Severe deficiencies and oversight contained in the Jupiter Windfarm Aeronautical Assessment Report, Annex J

Strip 1 - Kalbili Close:

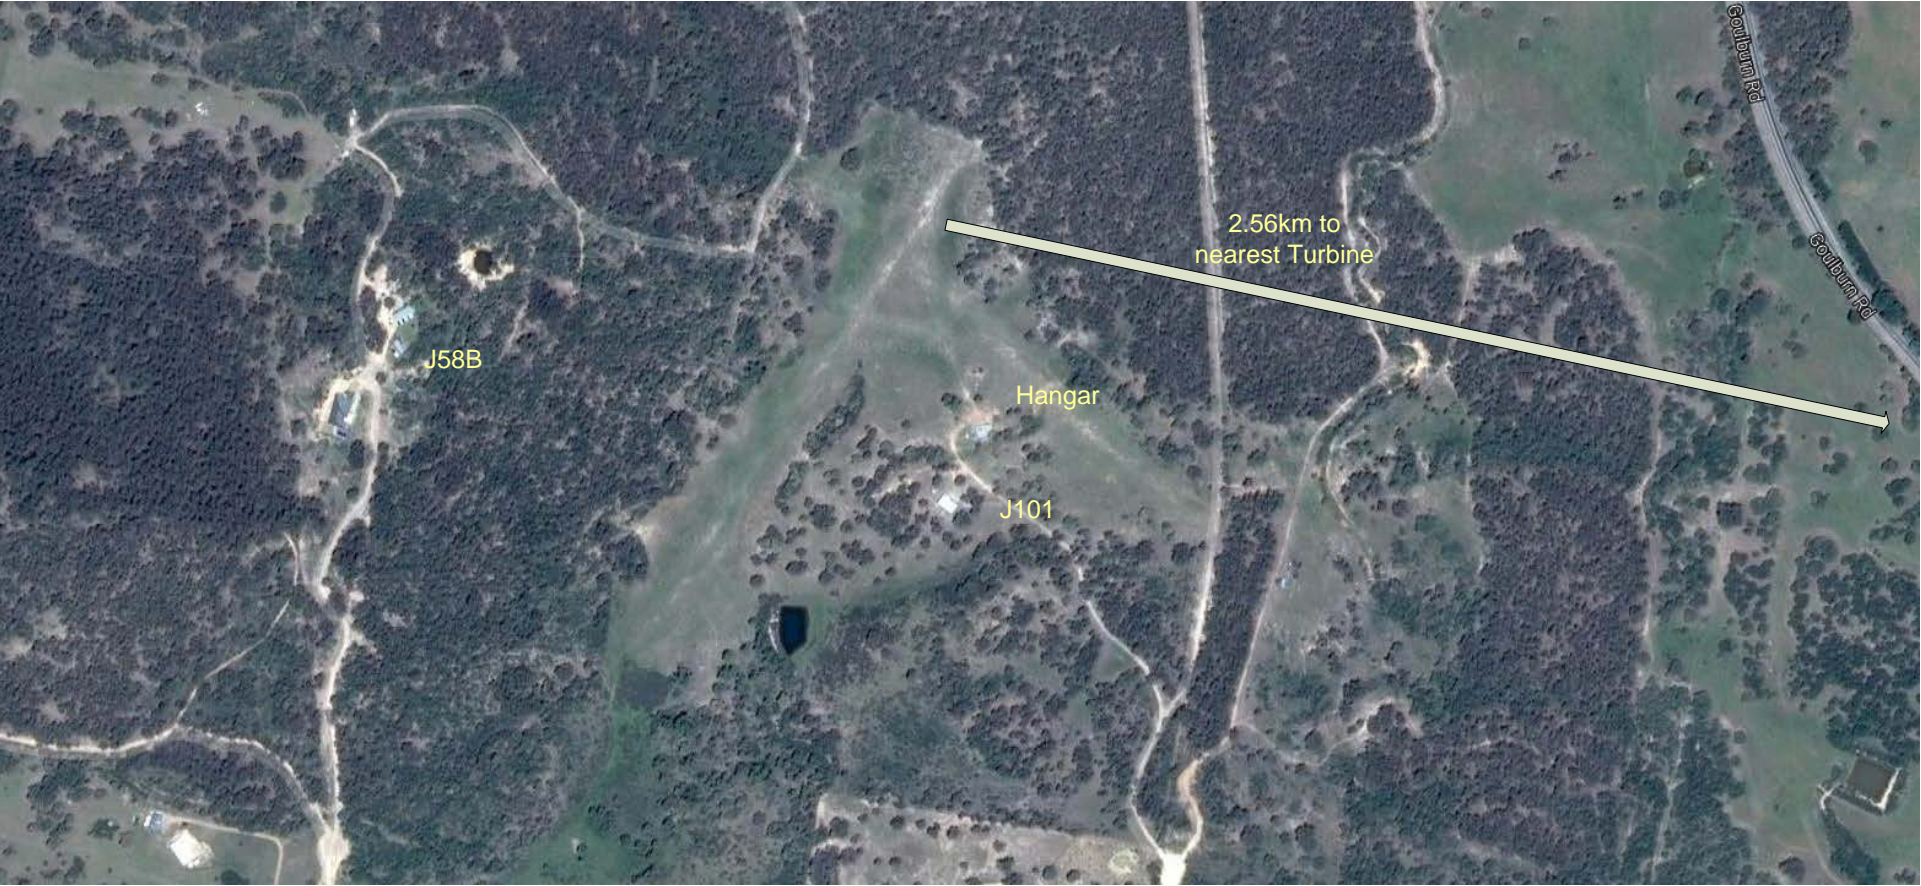
These two overlooked airstrips have take-off approaches that encroach within this $16D$ turbulence zone, as both strips are within 2.5 and 2.8km of the nearest turbines

- Situated at the very edge of the 16D turbulence zone,
- Have take-off and landing approaches that encroach well within this 16D zone
- Utilise aircraft that are highly susceptible to turbulence by virtue of their
 1. Weight and
 2. Design

The following graphic copied from the Visual Impact assessment document illustrates the proximity of these airstrips to the turbines as shown:

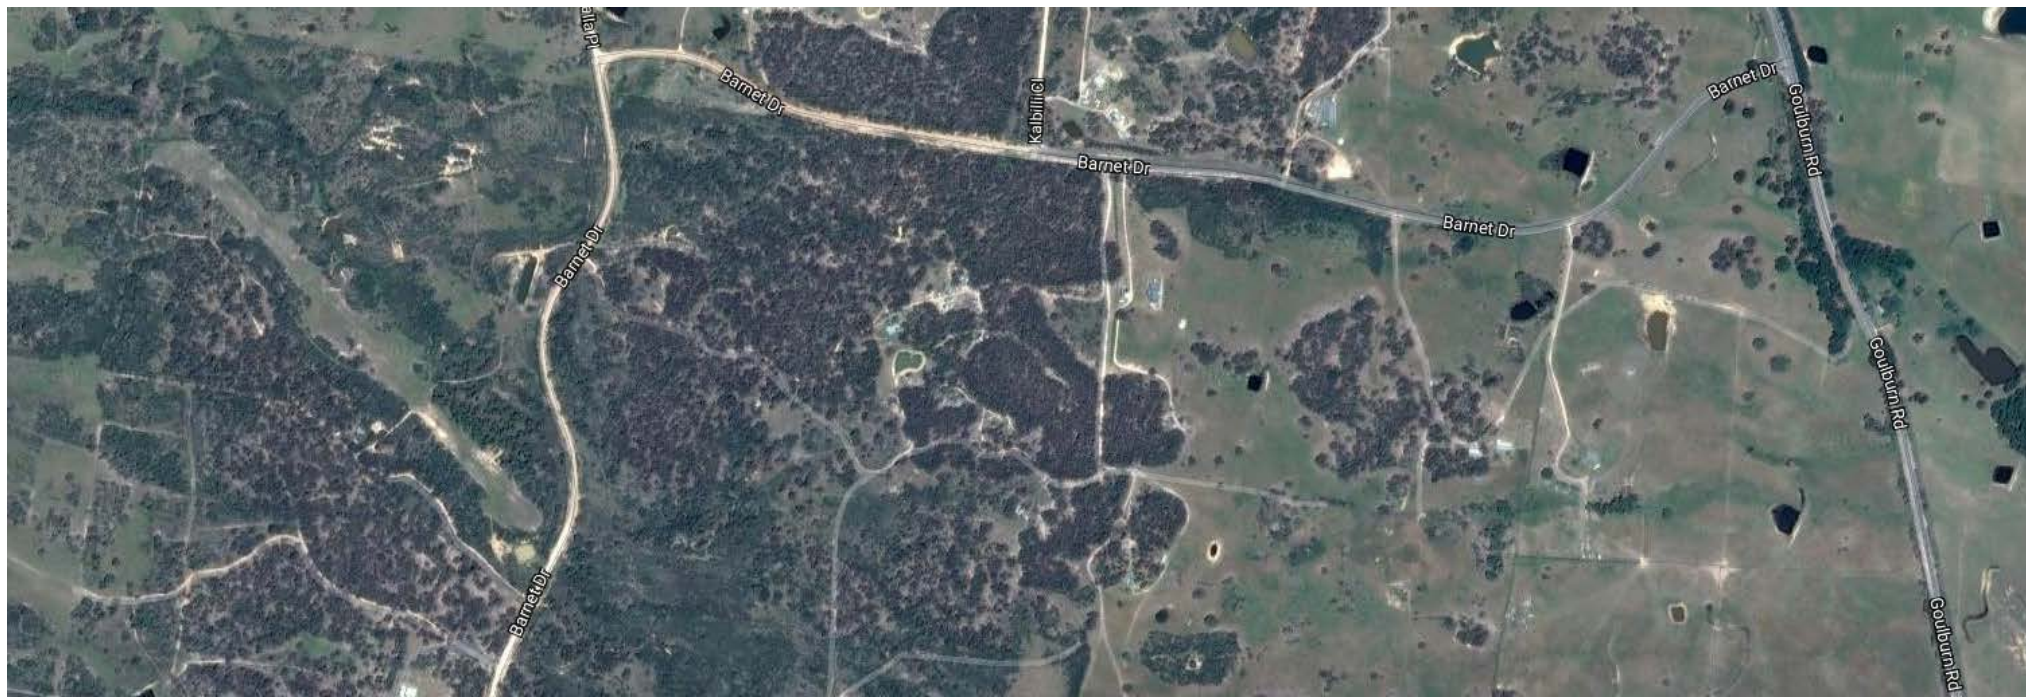
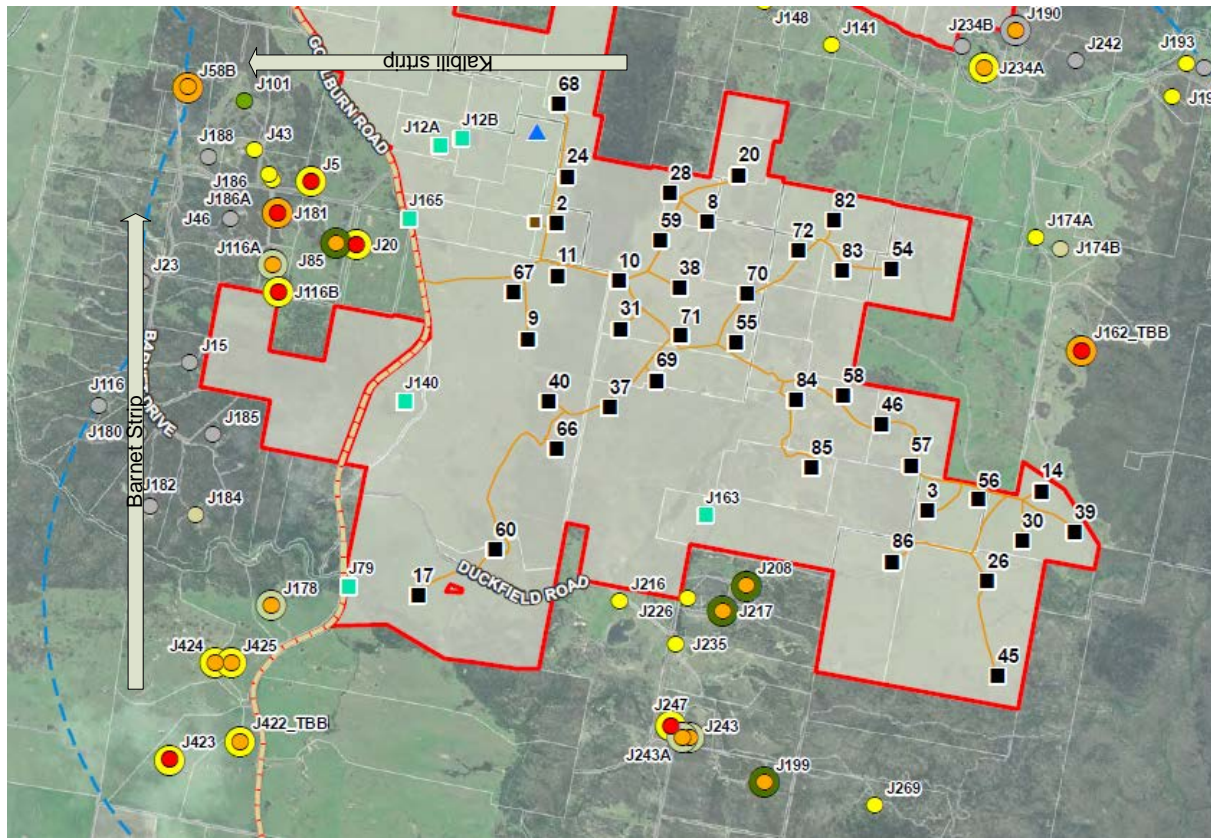
Clearly, these two ALA's that have not been identified in the assessment are:

In conclusion, the omission of these two well used private ALA's within this assessment has placed the pilots who frequent these strips at elevated risk of accident through the risk of turbulence, and the risk of collision with turbines in take-off and landing.

This section of the wind farm should be deleted or the entire proposal rejected due to the significantly increased risk to local air traffic that whilst apparently known to the proponent, has been overlooked within this assessment. The aviators affected purchased their land in this locality specifically in order to own private airstrips. This proposal destroys or severely impacts their ability and right to continue to do what they specifically bought in this locality to do, or forces them to the exposure of significantly elevated risk in order to continue.
